THIS IS FOR THE PURPOSE OF SECTION 4.55 APPLICATION TO COUNCIL ONLY

SECTION 4.55 ISSUE: FF'S FACADE MATERIAL UPDATED. LOWER SECTION OF KITCHEN'S SOUTHERN FACADE UPDATED.

41 & 43 BEACH ROAD COLLAROY
LO1 1 DP300846 AND LOT 2 SEC 7 DP7391

DRAWING TITLE
SOUTH & WEST ELEVATIONS
PROPOSED

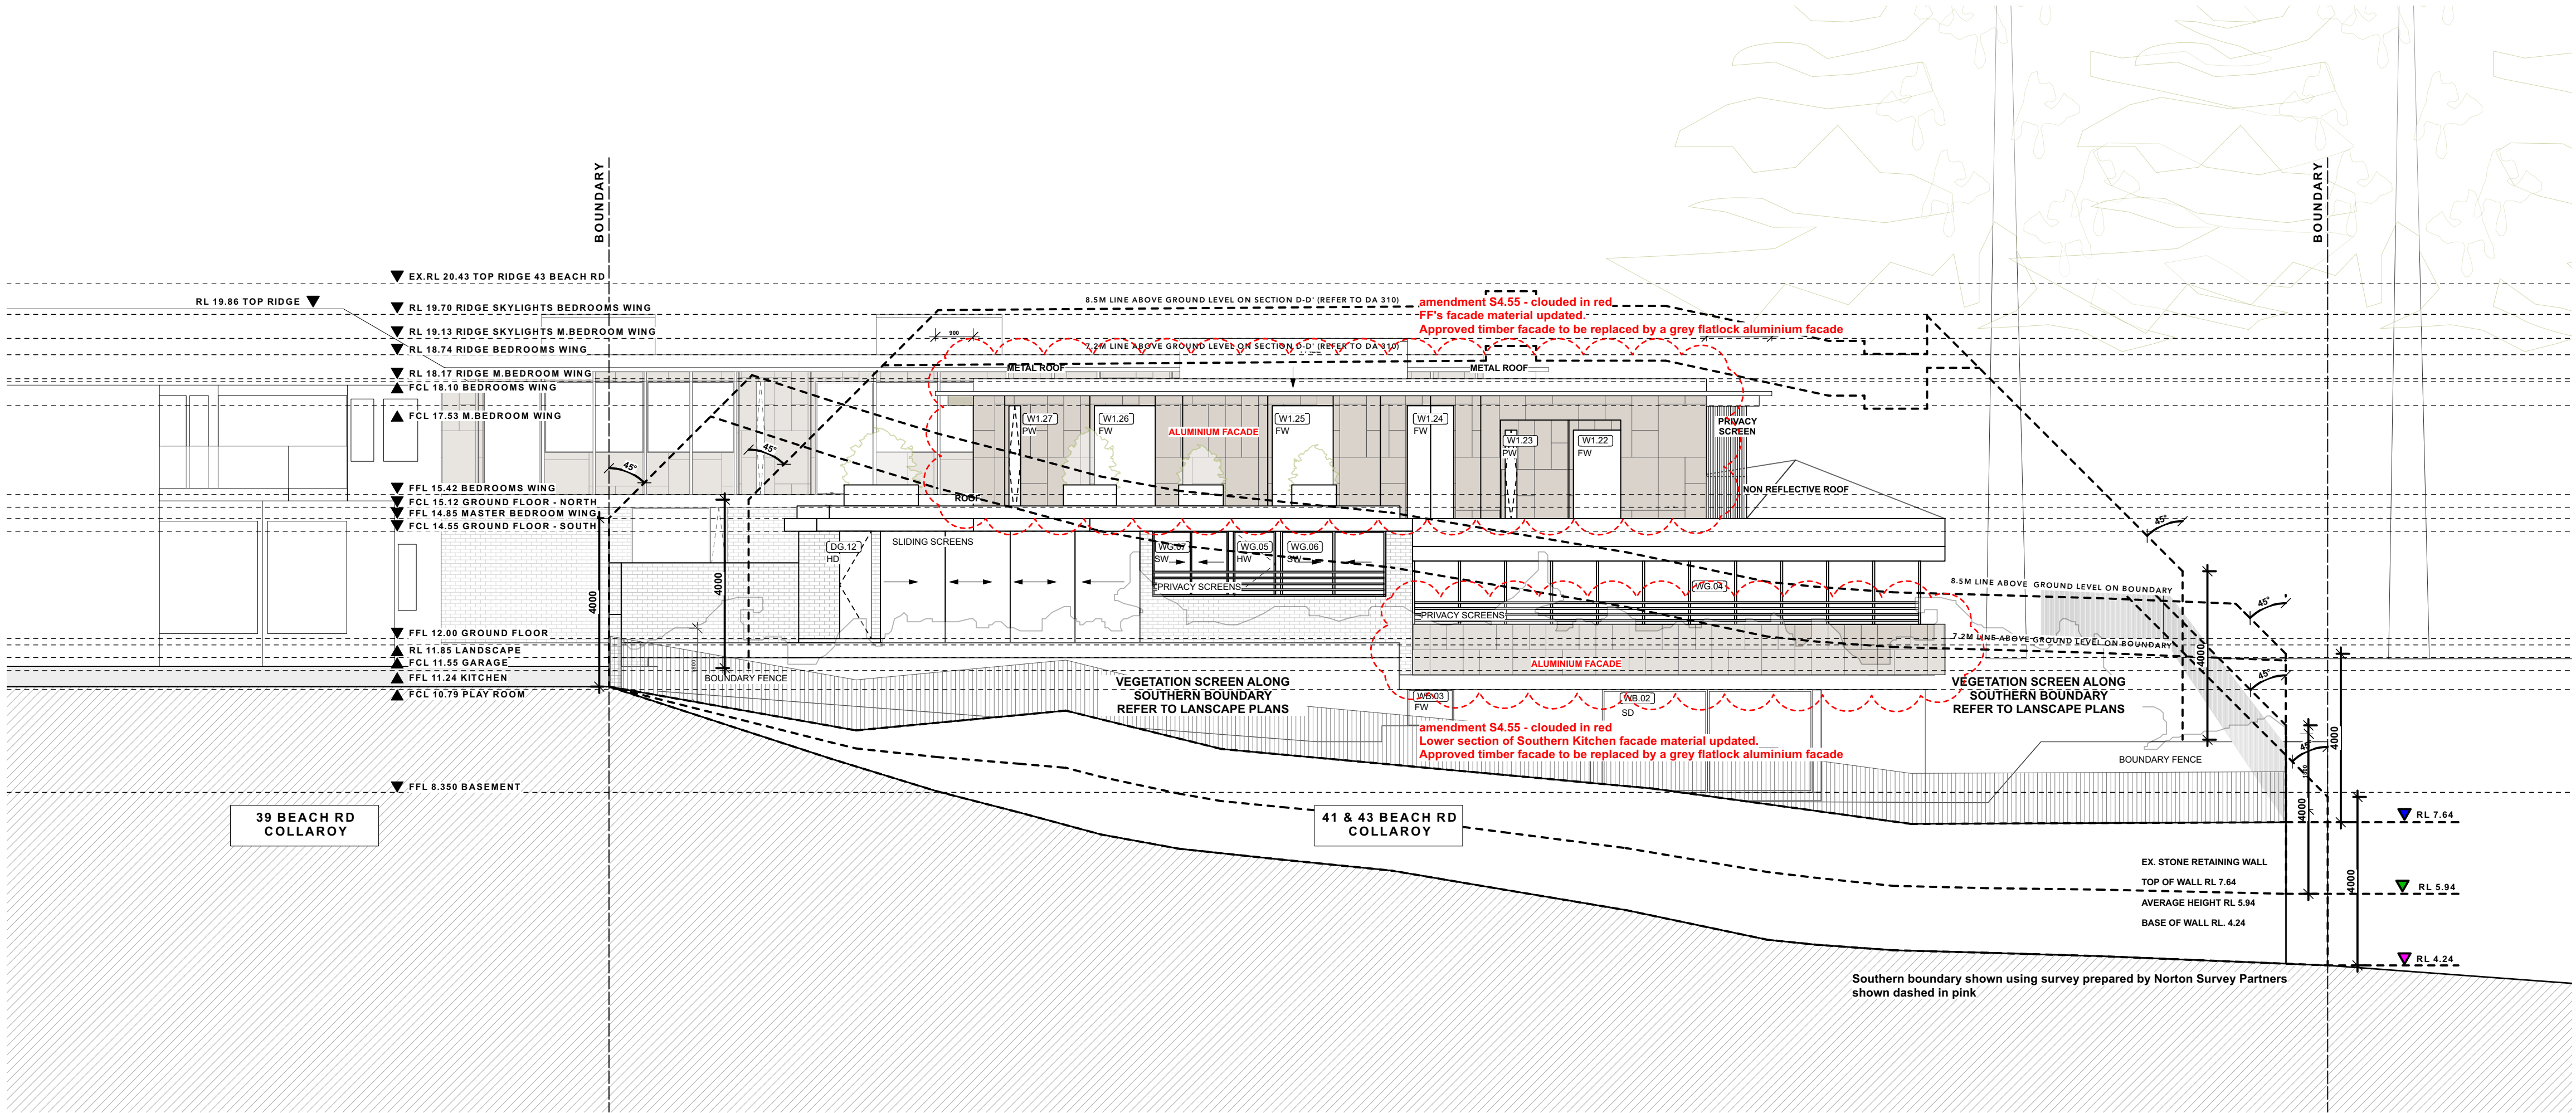
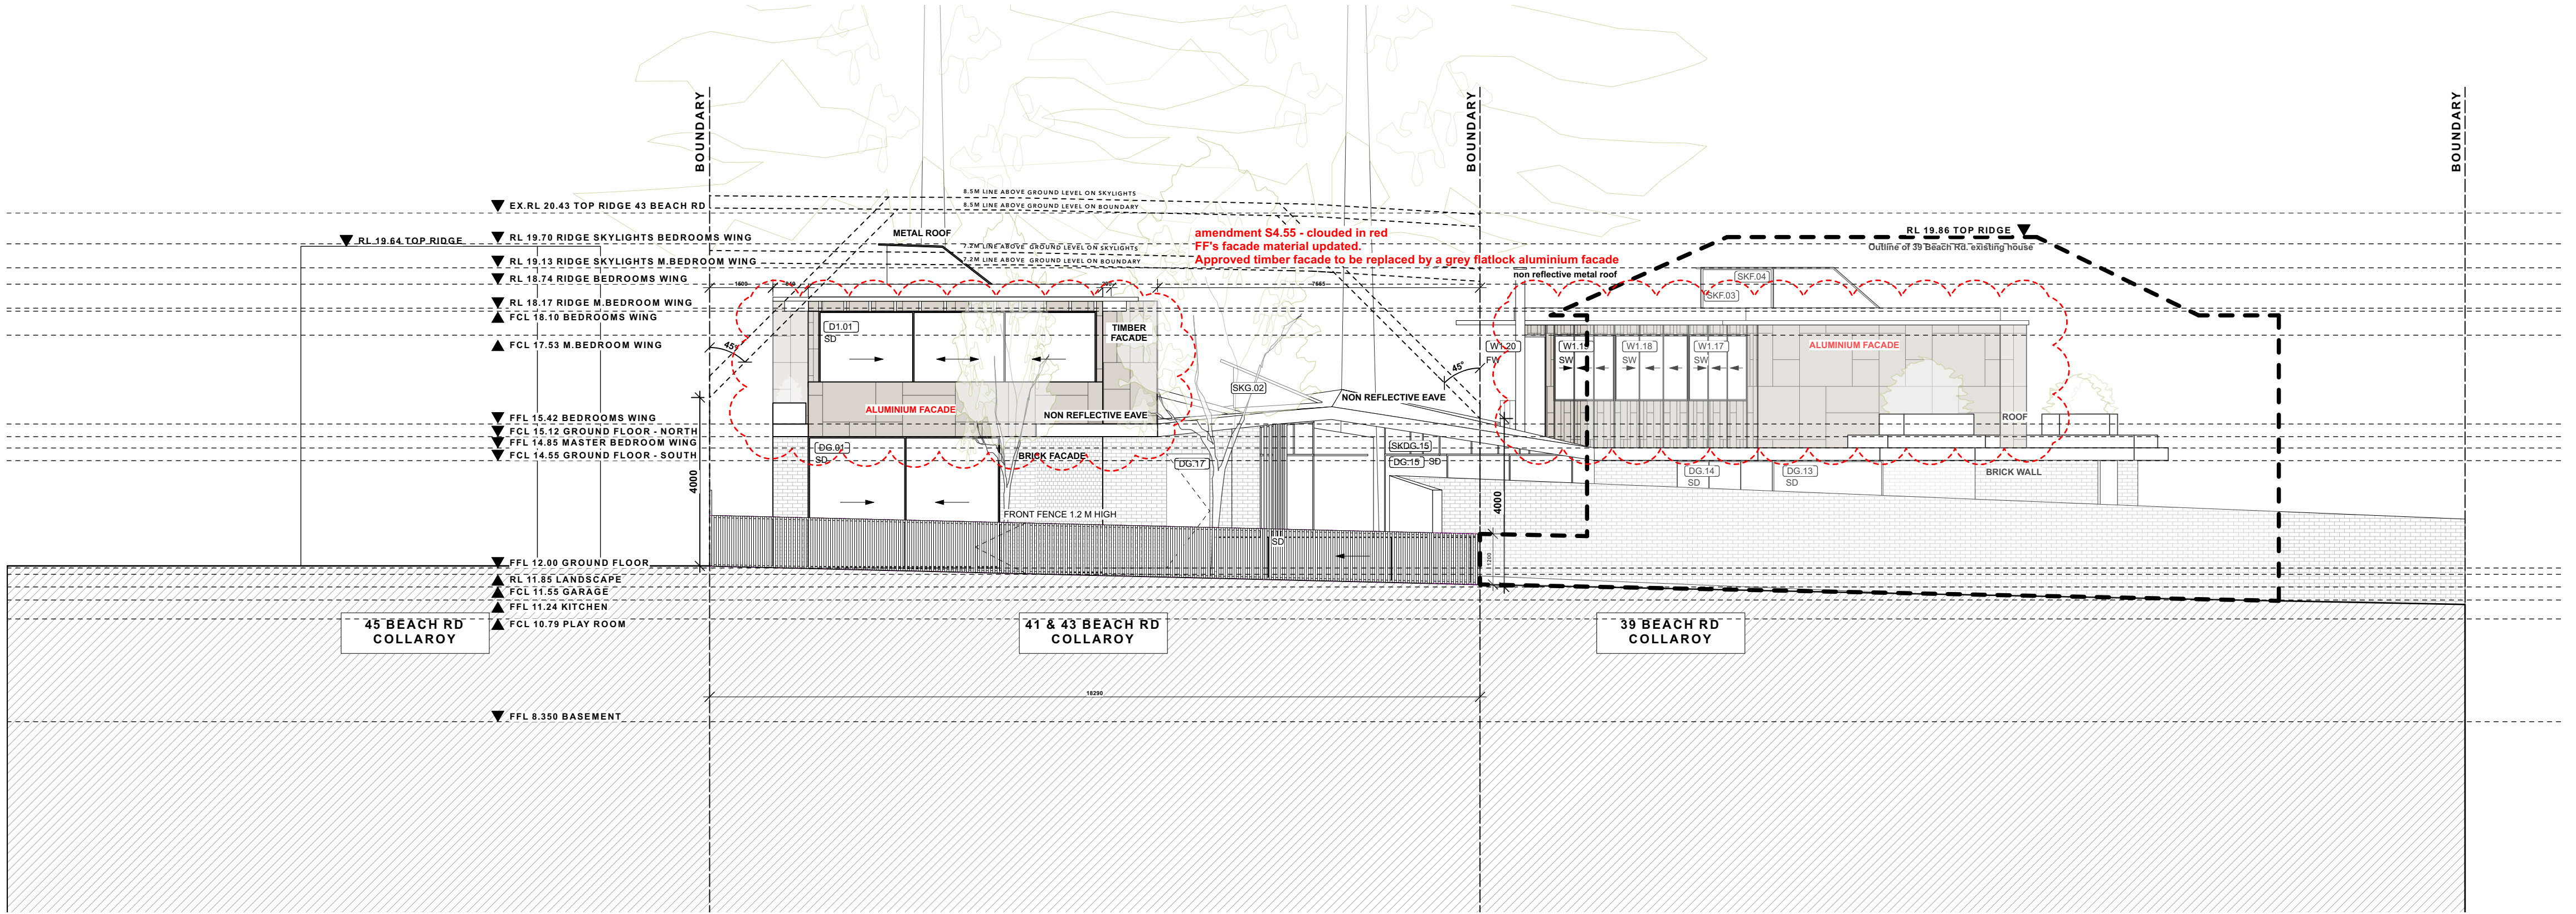
DESCRIPTION
SECTION 4.55 ISSUE: FF'S FACADE MATERIAL UPDATED. LOWER SECTION OF KITCHEN'S SOUTHERN FACADE UPDATED.

PROJECT		DATE	REVISION NUMBER:
41 & 43 BEACH ROAD COLLAROY LO1 1 DP300846 AND LOT 2 SEC 7 DP7391		16/03/2022	A
DRAWING TITLE		SCALE	DRAWING NO.
PROPOSED SECTIONS C-C' & E-E'		1:100 at A1 & 1:200 at A3	S4.55 310

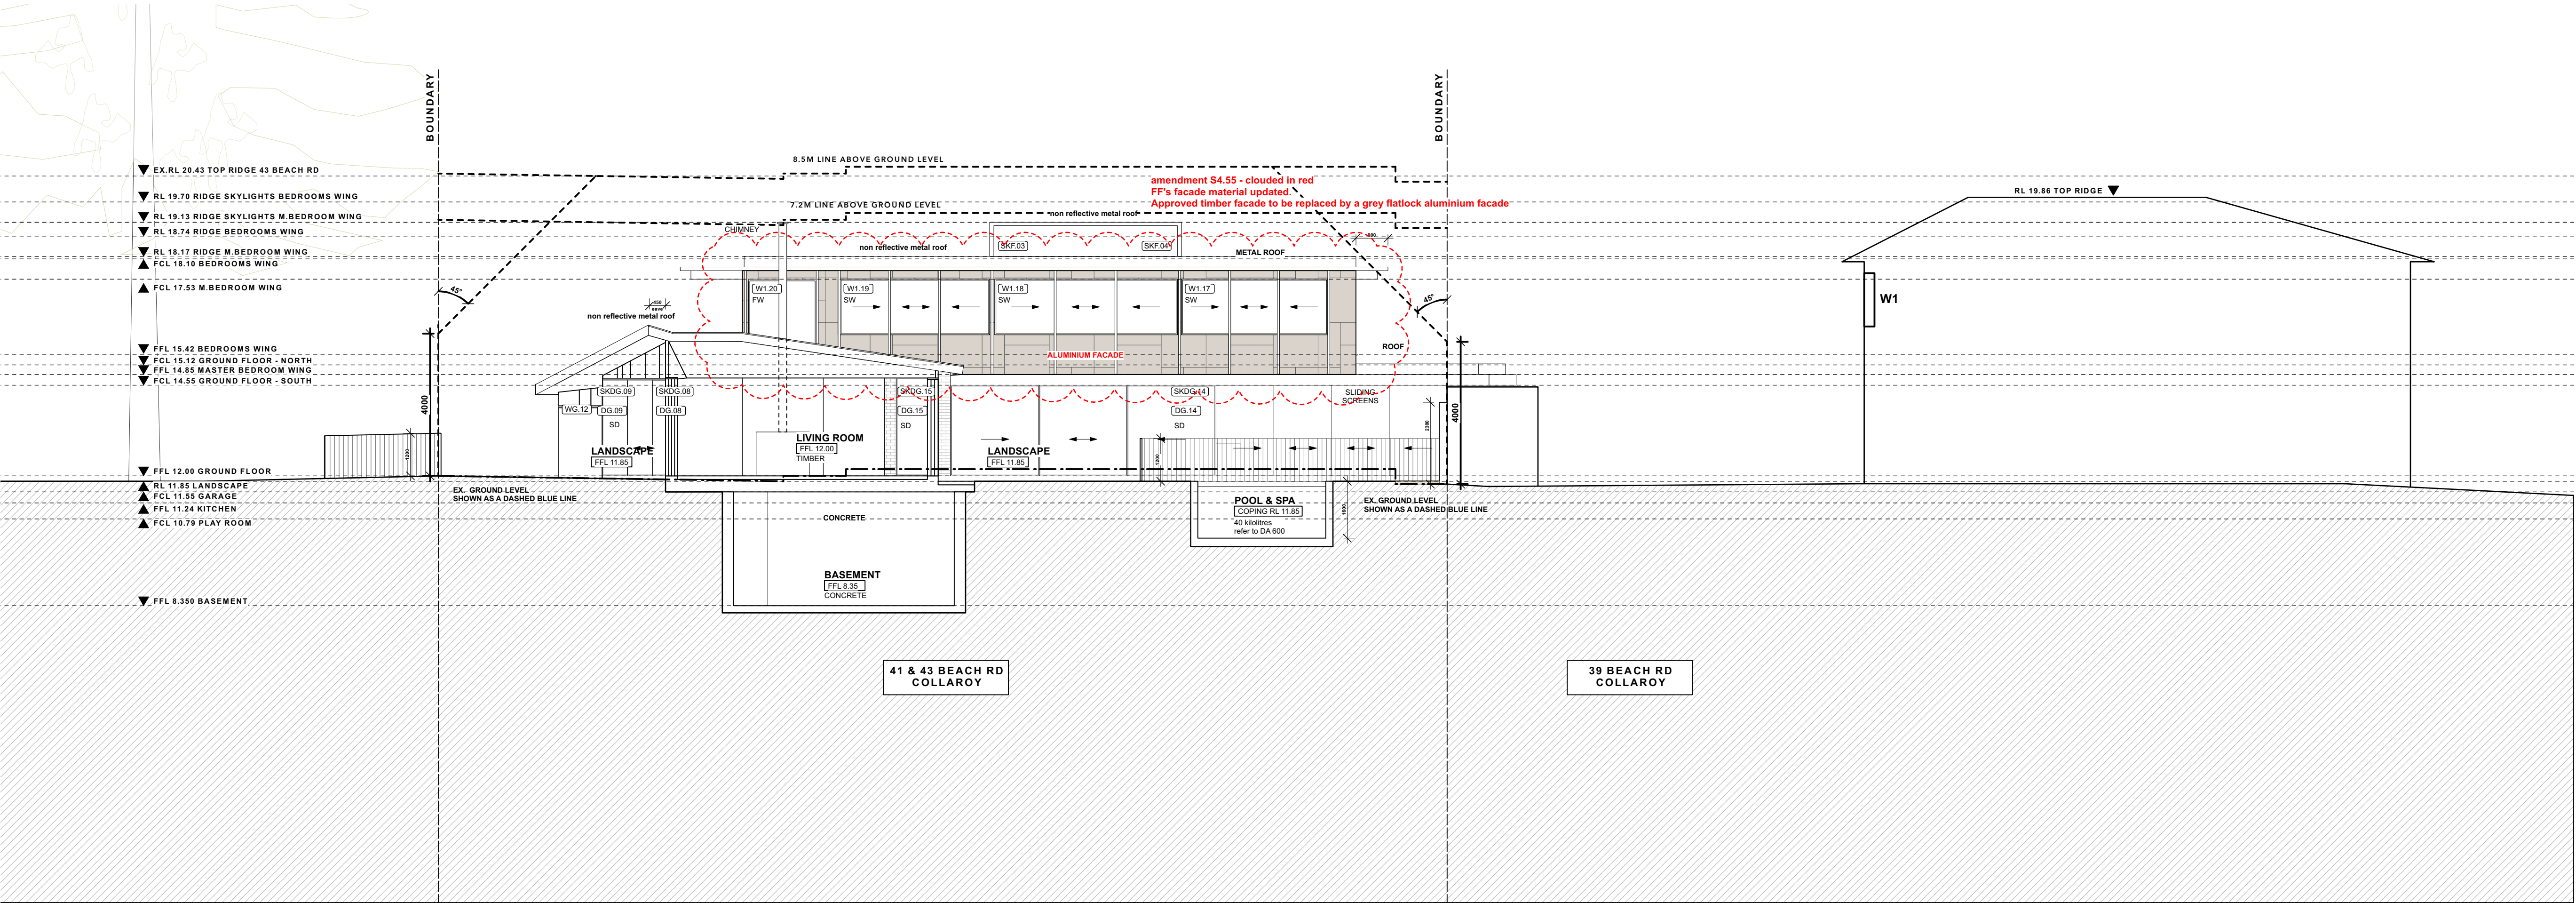
amendments:		
DATE	REV	DESCRIPTION
16/03/2022	A	SECTION 4.55 ISSUE: FF'S FACADE MATERIAL UPDATED. LOWER SECTION OF KITCHEN'S SOUTHERN FACADE UPDATED.

PROJECT		DATE	REVISION NUMBER:
41 & 43 BEACH ROAD COLLAROY LO1 1 DP300846 AND LOT 2 SEC 7 DP7391		16/03/2022	A
DRAWING TITLE	SCALE	DRAWING NO.	
MATERIALS AND FINISHES SCHEDULE	N/A	S4.55 400

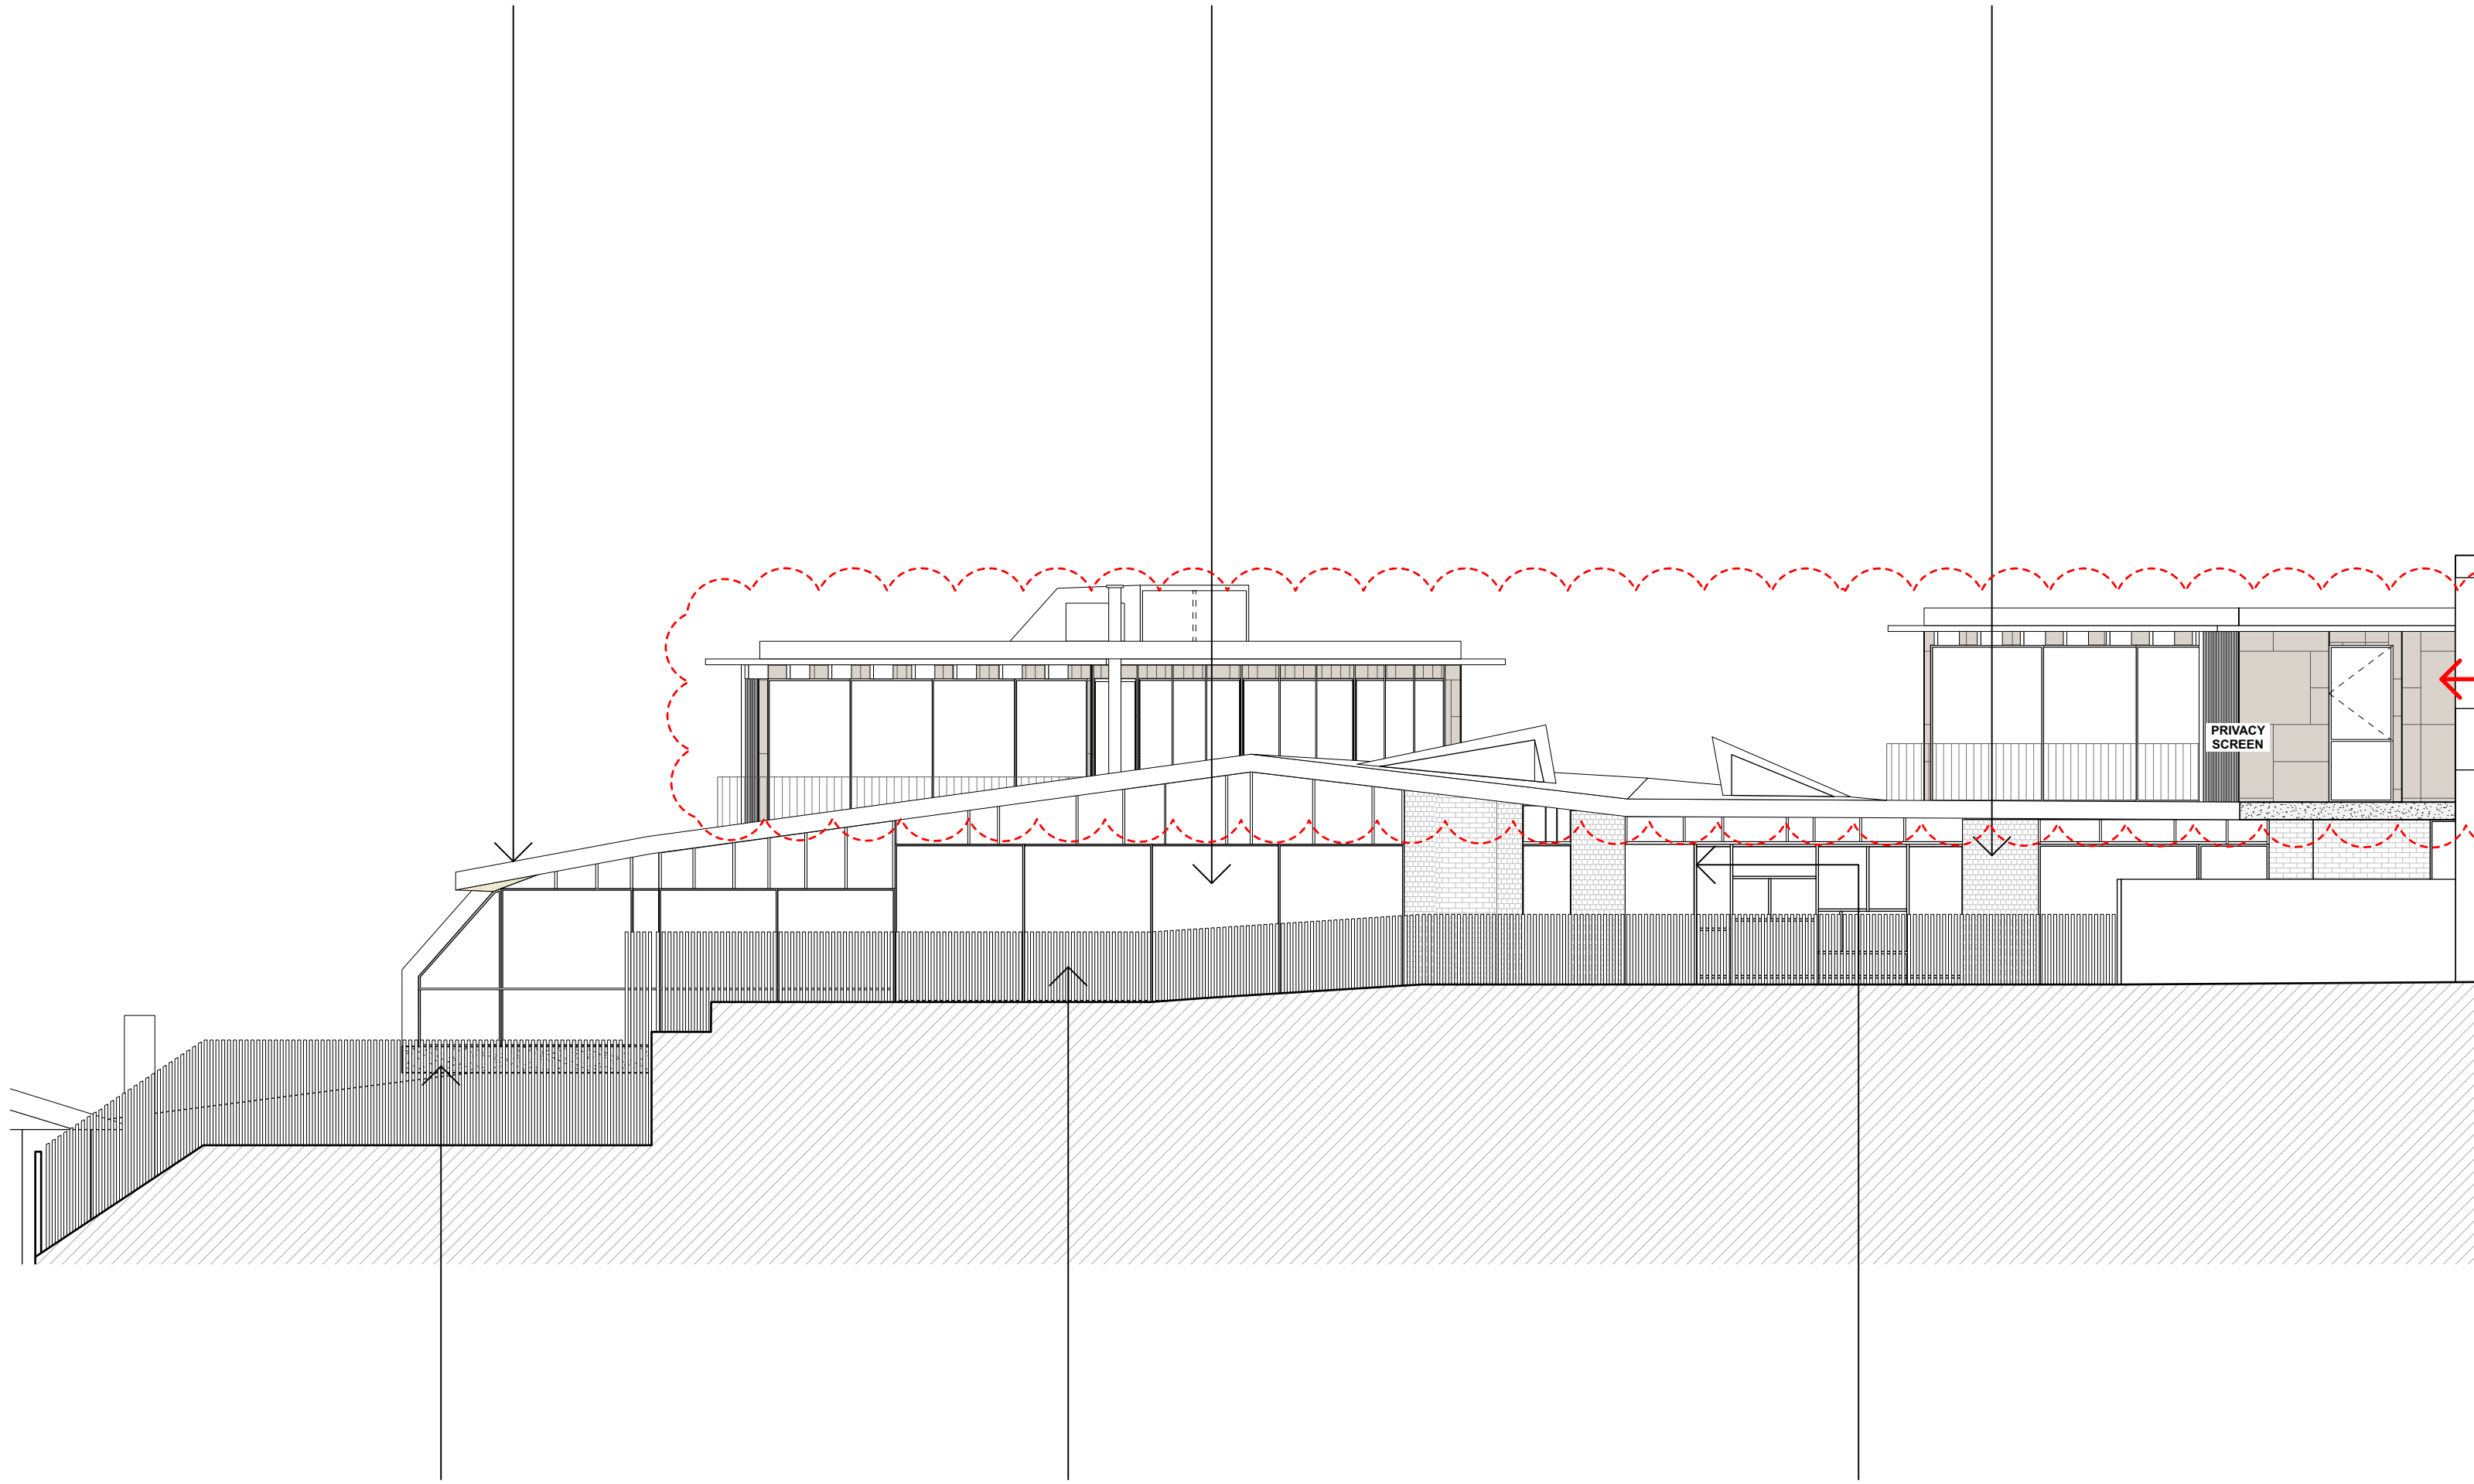
SECTION 4.55 APPLICATION AMENDMENT - SHOWN CLOUDED IN RED:
FF'S FACADE UPDATED
FLATLOCK ALUMINIUM CLADDING - GREY COLOUR - MATT FINISH
